20191002 - October's Specifications Committee Meeting

October Specifications Committee Meeting Agenda

FIGURE 506.6.8.1

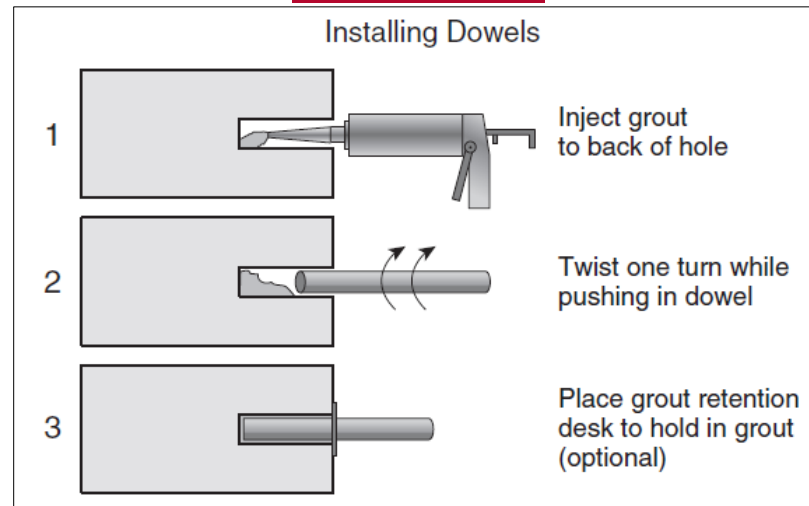
inch (230 mm) length, the repair boundary shall be re-sawed 1 foot (300 mm) back from the existing repair boundary, and dowels shall be re-installed. This work shall be done at the Contractor's expense.

The surface edges of all patches shall be tooled, formed and/or sawed, and cleaned to result in a properly dimensioned reservoir for sealant. All transverse and longitudinal joints at pavement repair locations shall be sealed in accordance with manufacturer's recommendations unless otherwise approved by the Engineer.
